RECEIPT DATE: 12/08/2020 **ONSITE SEWAGE DISPOSAL SYSTEM** P 572886  
 APPROVAL DATE: 10/05/2020 **PERMIT: CONSTRUCTION** A \_\_\_\_\_  
 PROPERTY ADDRESS: 18423 Hidden Creek Way  
 SUBDIVISION: Windsor Forest Knolls LOT: 18 TAX ID: 04-373340  
 CONTRACTOR: FARM AND HOME EXC. EMAIL: \_\_\_\_\_  
 CONTRACTOR ADDRESS: 901 DRIVER ROAD MARIOTTVILLE MD PHONE: 410 442 2139  
 PROPERTY OWNER: Keystone Custom Homes EMAIL: \_\_\_\_\_  
 OWNER ADDRESS: 227 Granite Run Dr. PHONE: \_\_\_\_\_  
 SEPTIC TANK SIZE (GALLONS): 2000 TANK MANUFACTURER: MBI  
 PUMP MODEL: Zoeller PUMP SIZE 0.3 PUMP TANK CAPACITY: 2000

**WINDSOR FOREST KNOLLS**  
**LOTS 1 THRU 18**  
**PLAT No. 19396**  
**LOT No. 18**

PROJECT: WINDSOR FOREST KNOLLS LOT 18	
LOCATION: TAX MAP: 6 - GRID: 16 - PARCEL: 57 18423 HIDDEN CREEK WAY - TAX ID: 04-373340 ELECTION DISTRICT NO. 4 - HOWARD COUNTY, MARYLAND	
TITLE: ONSITE SEWAGE DISPOSAL PLAN	
HOUSE TYPE: CUSTOM - KEYSTONE HOMES	
DATE: DECEMBER, 2020	PROJECT NO. 2986
SCALE: AS SHOWN	DRAWING 1 OF 4

FOUNDATION DETAIL  
SCALE: 1" = 30'

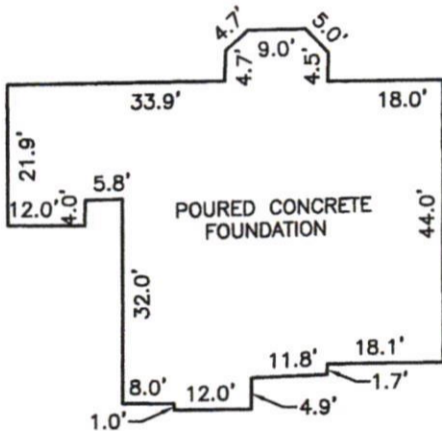
i understand you are off work today. Our office received the wall check for 18423 Hidden Creek Way (Lot 18). On the OSDS Plan, the proposed FF elevation = 790.20. On the wall check, the top of wall elevation = 788.3. On the septic profile, the SHC fall is 1%. The SHC fall may not be less than 1%. Based on this info. can we still get proper fall or do we need to switch to hung sewer?

Hank – on Keystone's homes, the top of wall is 8.67' above the basement floor.  $788.3 - 8.67 = 779.63$  sewer invert at the wall is 777.18.  $779.63 - 777.18 = 2.45'$  That's spitting distance to the 2.5' we usually use, so I think it should be fine. I also took a quick look at the house plan, and the basement bath rough-in is reasonably close to where we come out from under the foundation.

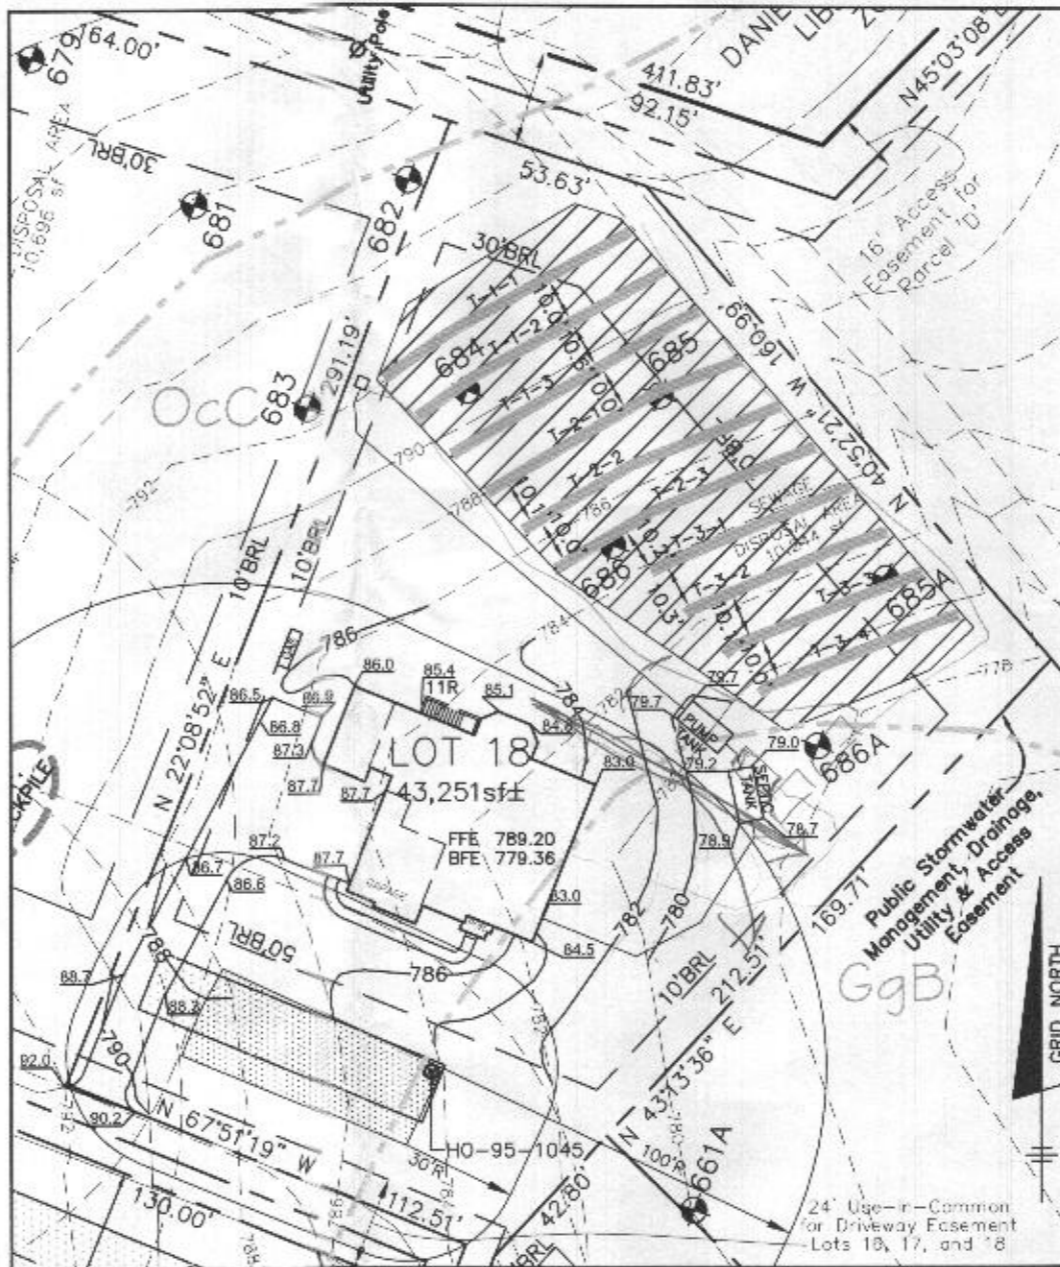
Just following up on your previous email exchange with Hank – the septic profile for 18423 Hidden Creek Way shows the sewer line coming out below the footer, however it is annotated to say “cellar not serviced via gravity, pump req’d for basement service”. (see below) Can you clarify if this is a hung sewer or it comes out below the footer?

Susan – I think I may have put that note on there because it was ‘close’. However, the profile shows 10’ basement walls, and all of the plans I have currently, show 9’ walls. So, that error is part of why it was close. If the walls have been constructed at 9’ (which would be 8.67’ concrete wall ‘above’ the basement slab elevation), they should be able to get under the slab and provide all of the service by gravity.

I apologize for the confusion. Occasionally, the plans get tweaked between the time I do the first layout and the final.

**LOT 18 SEPTIC PROFILE**  
 SCALE: 1"=50' HORIZ., 1"=5' VERT.

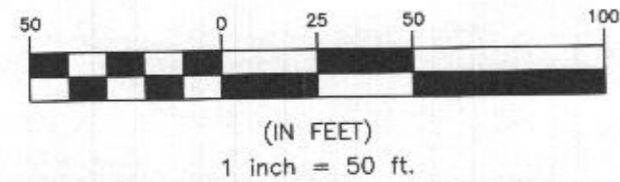
NOTE: CELLAR NOT SERVICED VIA GRAVITY, PUMP REQ'D FOR BASEMENT SERVICE
